**Addendum No. 3**

**Final Environmental Impact Report  
for Metro Gold Line Foothill Extension - Azusa  
to Montclair (SCH 2010121069)**

**Evaluating Minor Design Changes of the Project  
Azusa to Montclair**

Metro Gold Line Foothill Extension Construction Authority  
March 2016

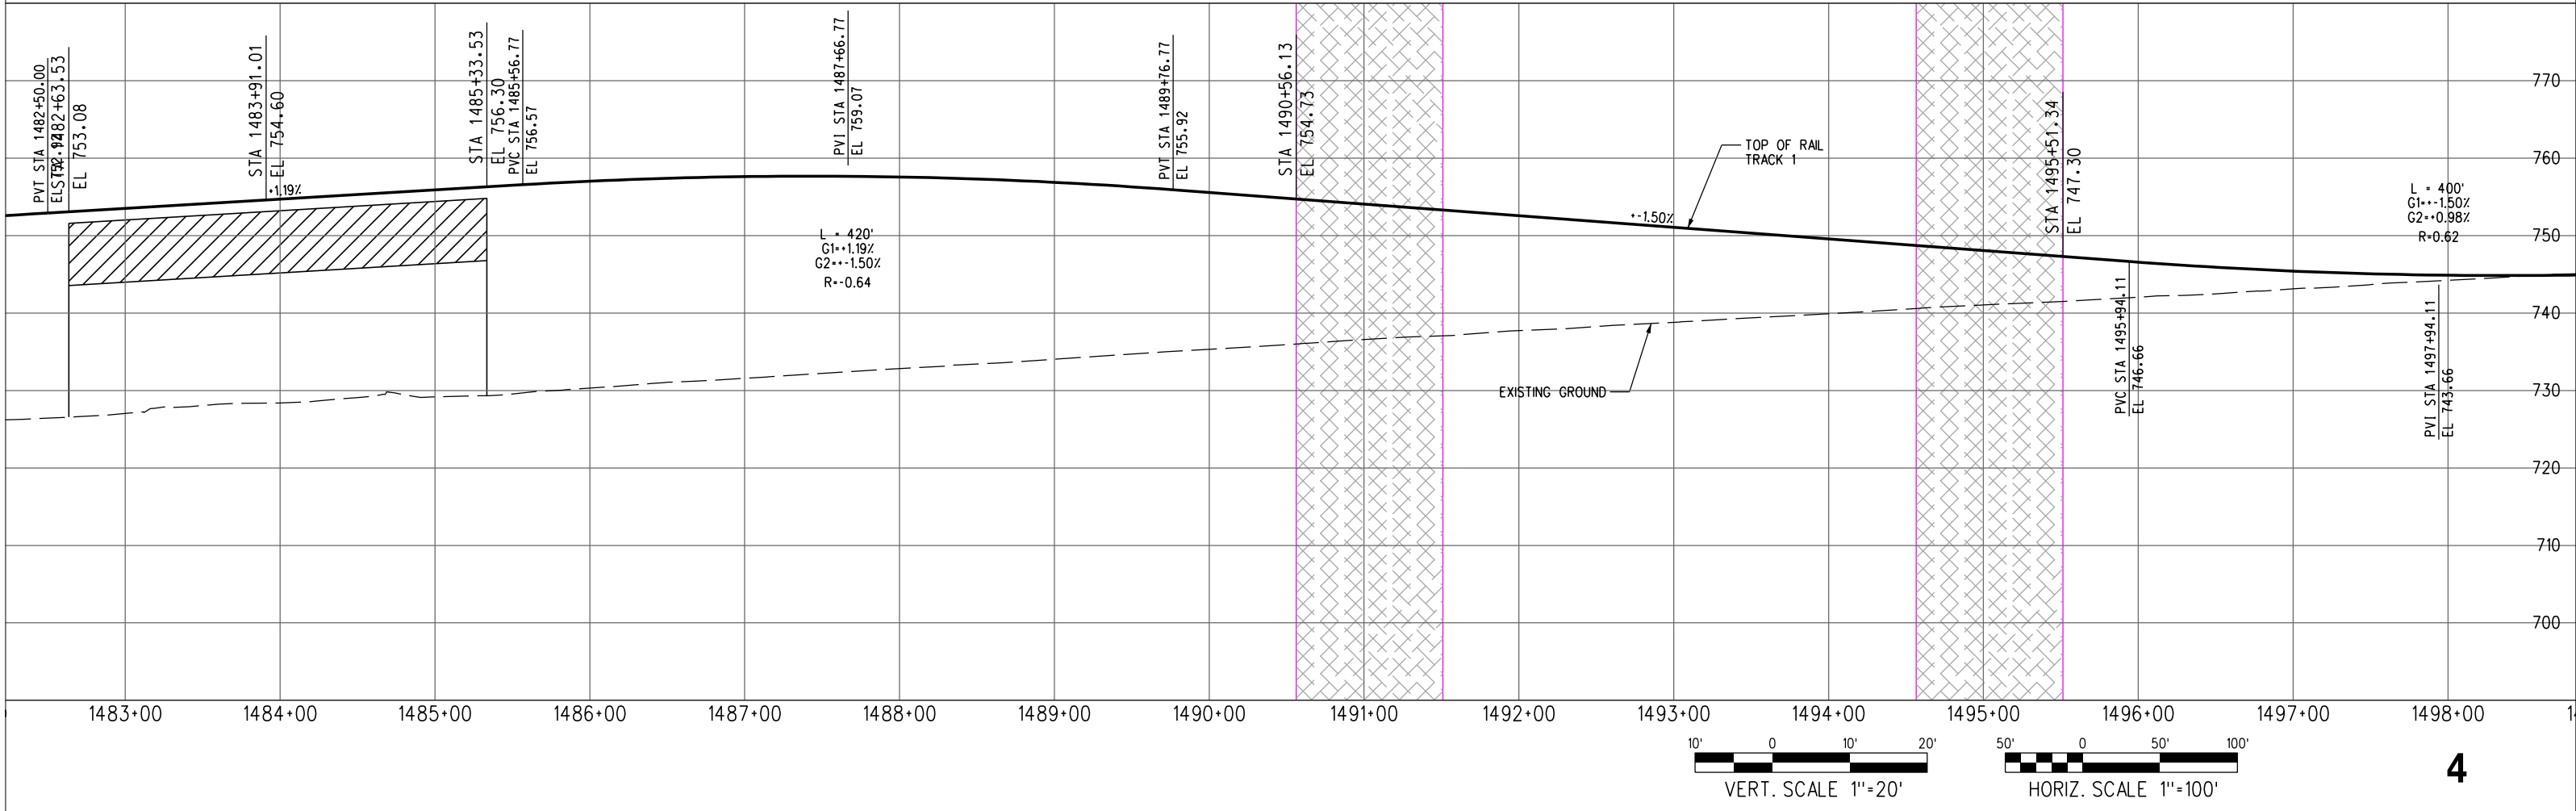
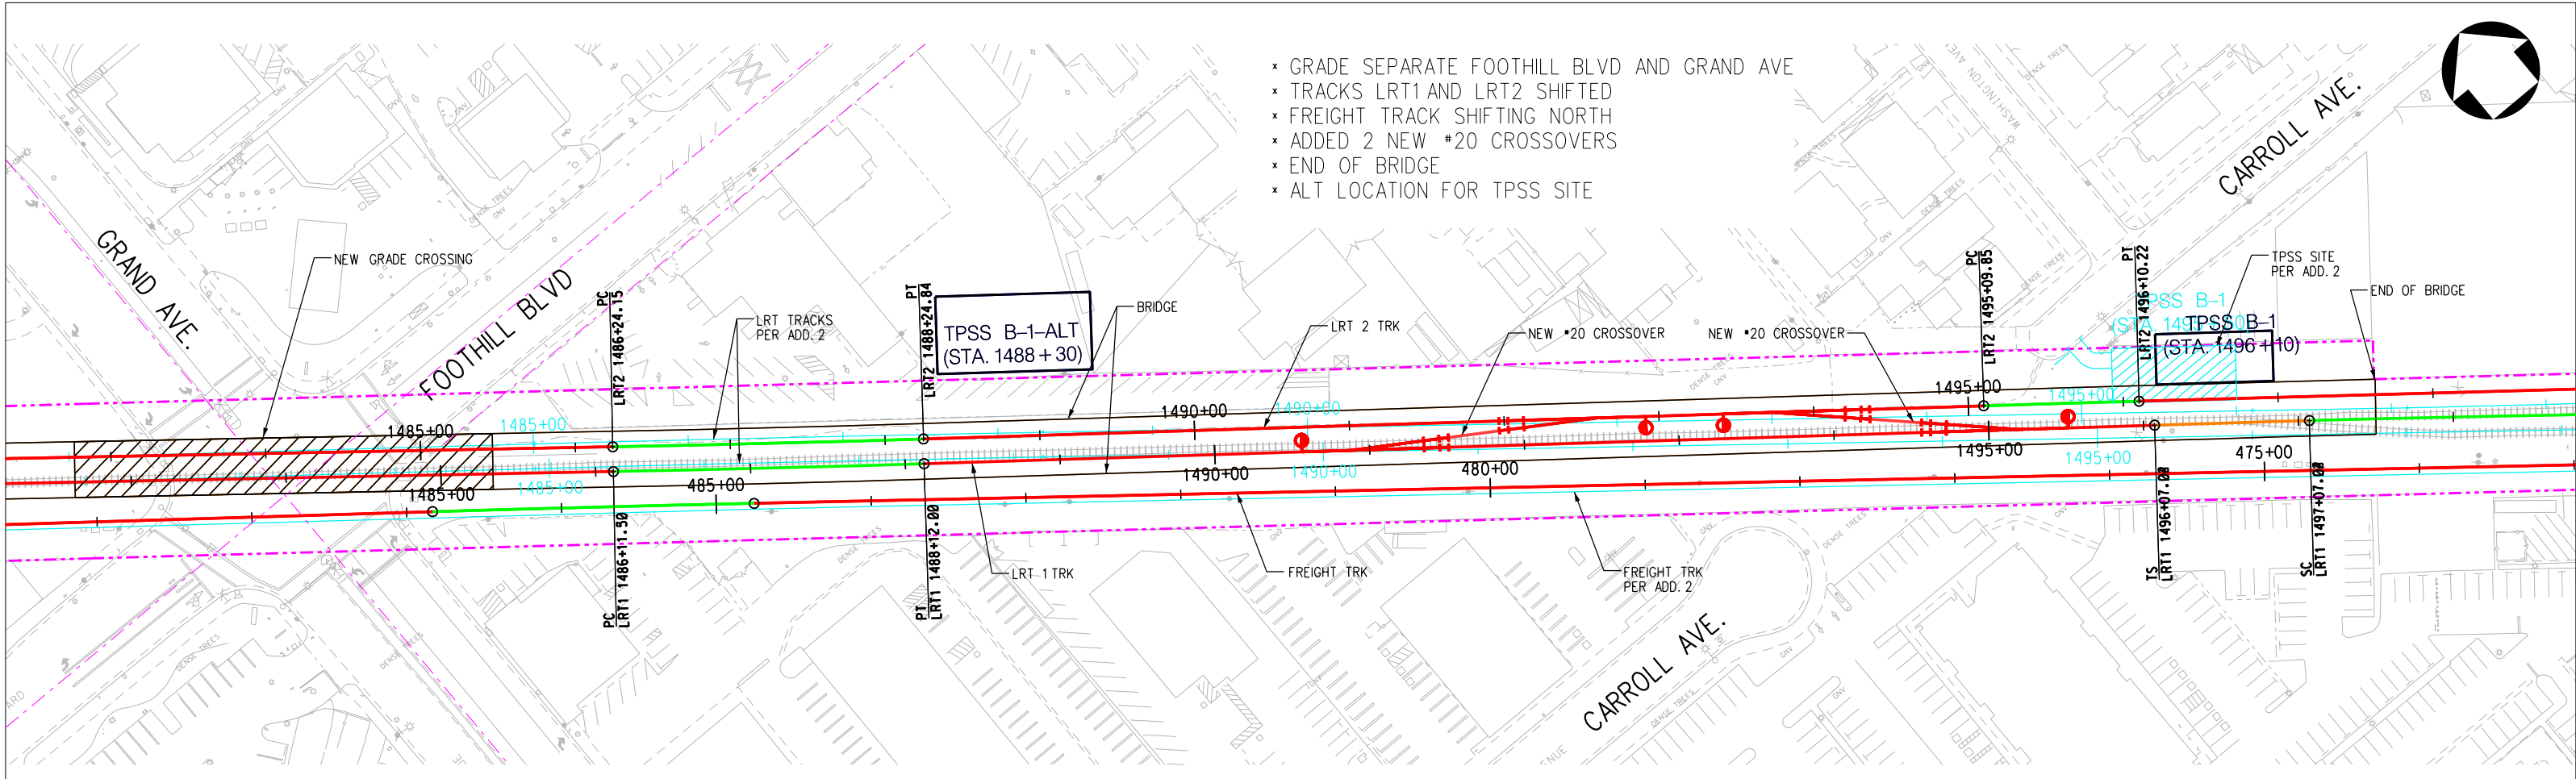
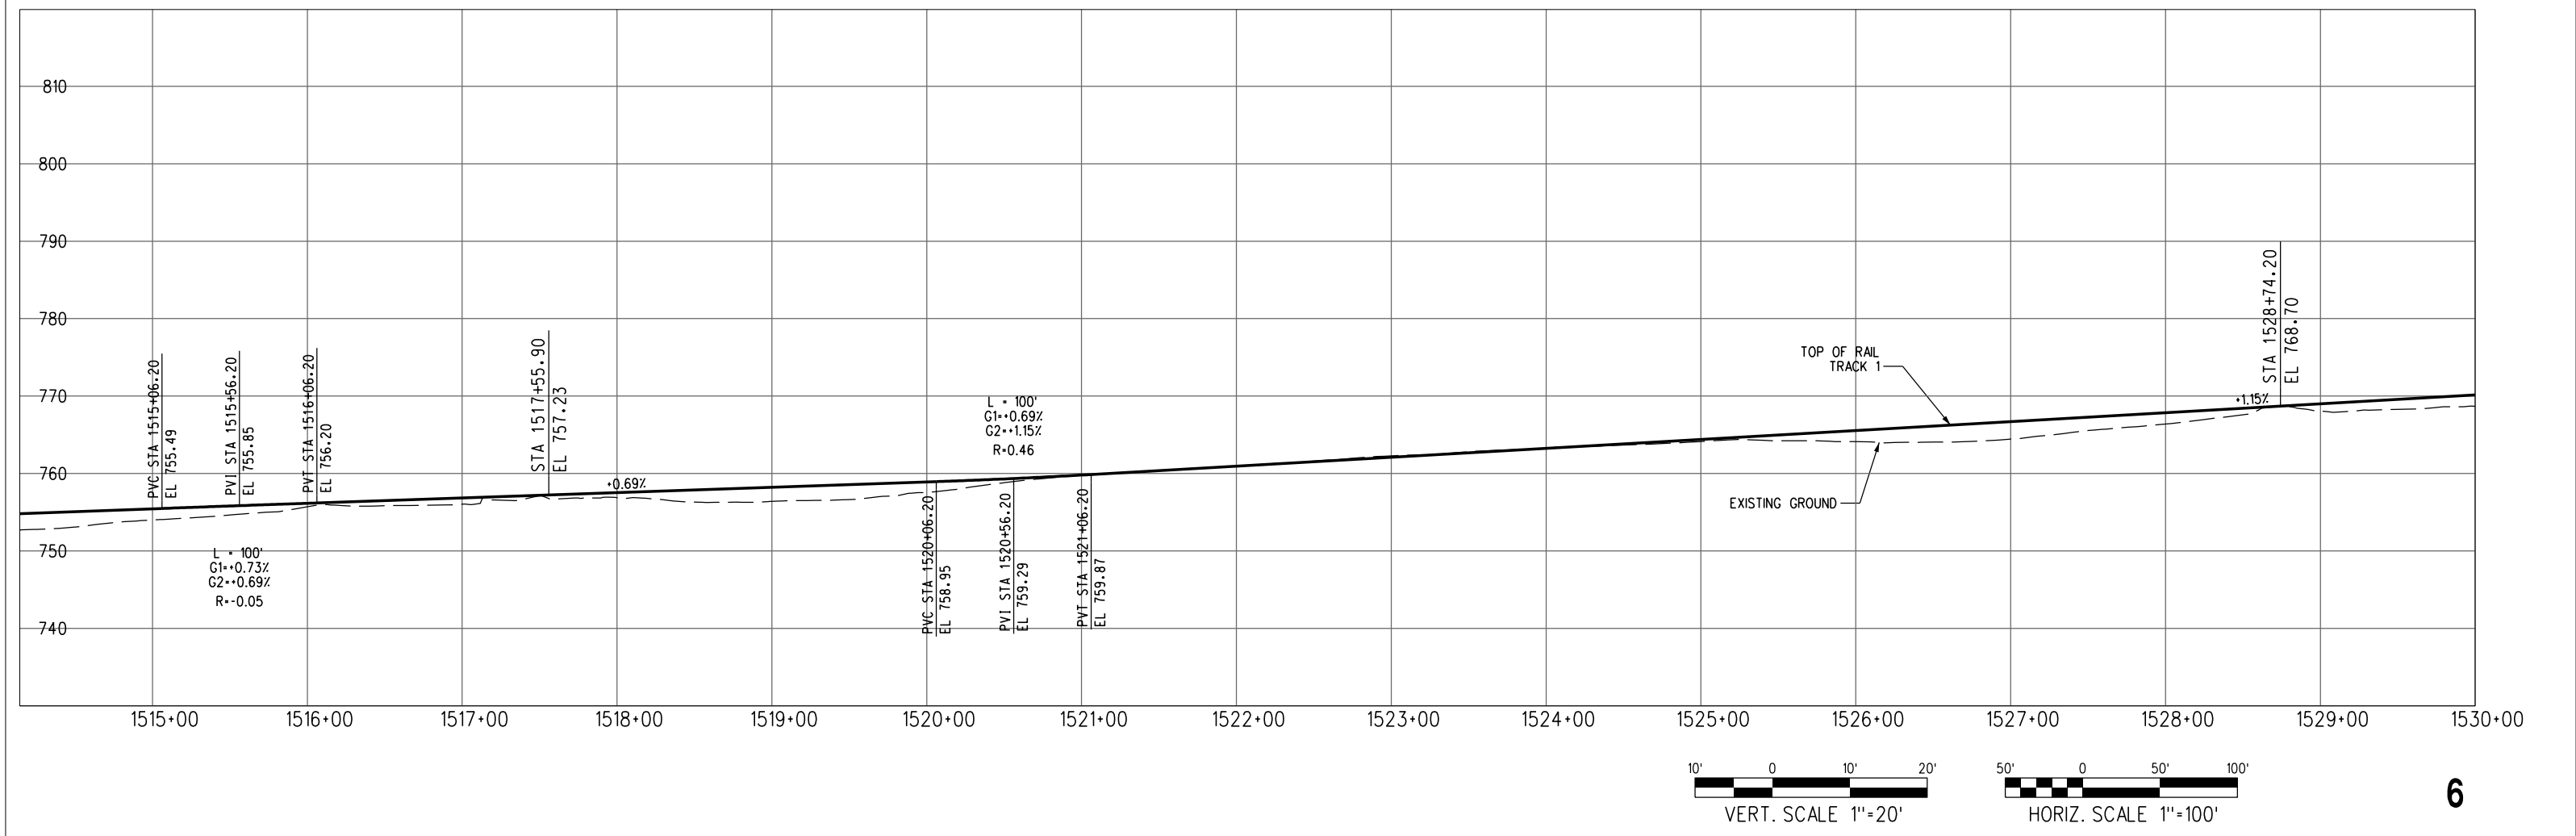
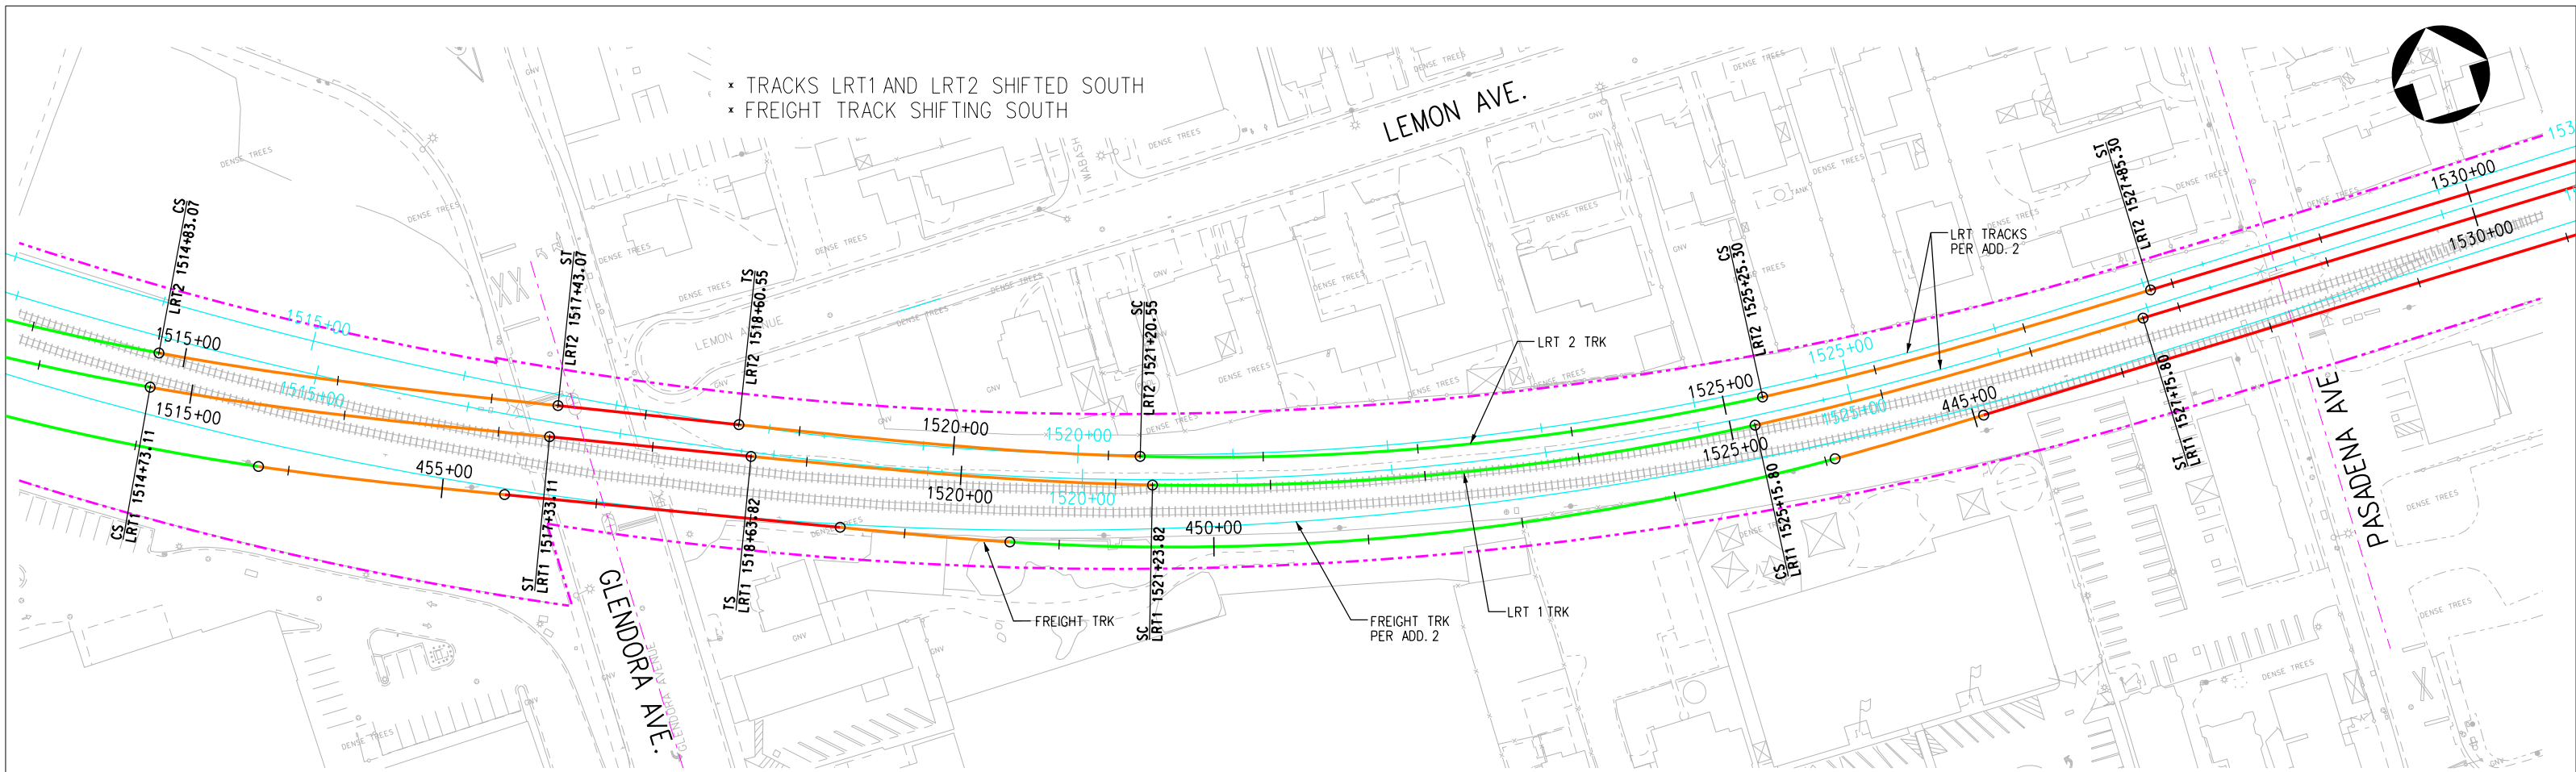
- \* GRADE SEPARATE FOOTHILL BLVD AND GRAND AVE
- \* TRACKS LRT1 AND LRT2 SHIFTED
- \* FREIGHT TRACK SHIFTING NORTH
- \* ADDED 2 NEW #20 CROSSOVERS
- \* END OF BRIDGE
- \* ALT LOCATION FOR TPSS SITE
